Re: MCB Camp Lejeune Meeting Minutes, 60 Percent Design for  
Soil Remediation Operable Unit Number 10 (Site 35)

**MEETING MINUTES  
60% DESIGN REVIEW  
MCB CAMP LEJEUNE, NORTH CAROLINA  
SEPTEMBER 29, 1994**

**MEETING MINUTES  
60% DESIGN REVIEW FOLLOW-UP  
MCB CAMP LEJEUNE, NORTH CAROLINA  
SEPTEMBER 29, 1994**

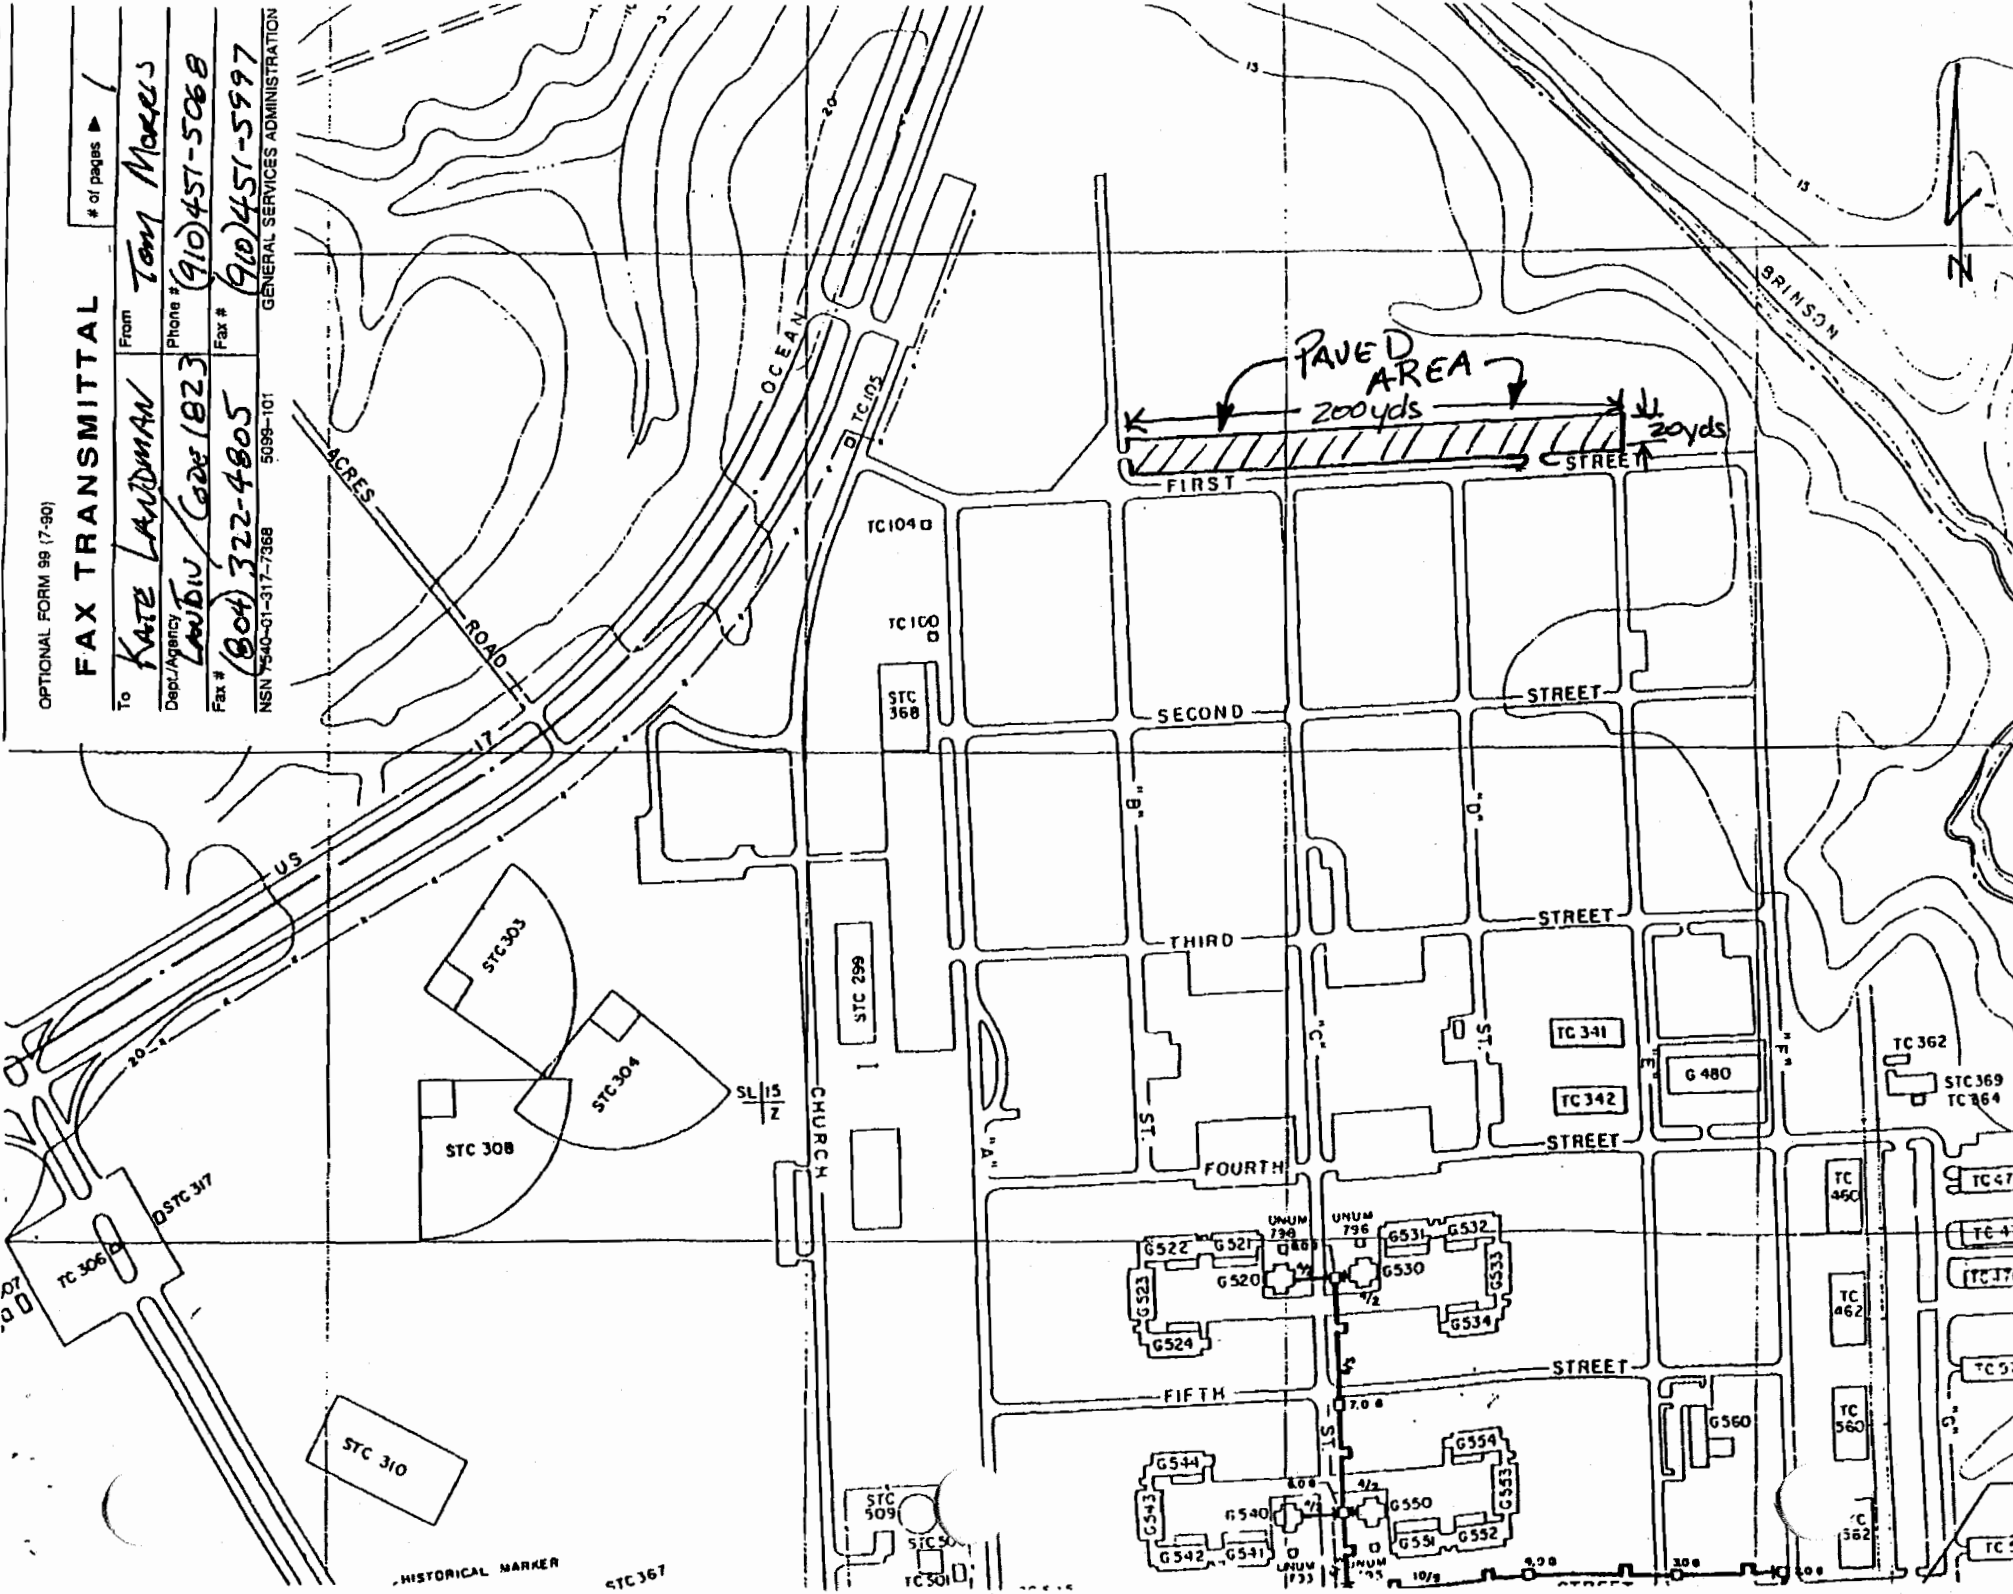
**Action Item - Tom Morris, Camp Lejeune EMD, indicated he would check into the availability of the parcel located between "D" and "E" streets and report back to Baker. (Note: Tom Morris reports that neither of these suggested locations will be available for use as the Soil Staging Area. However, Camp Geiger will permit the use of a asphalt-covered area located to the north of First Street. This is the only area that will be available for our use. A map of this area is attached to these minutes for reference.)**
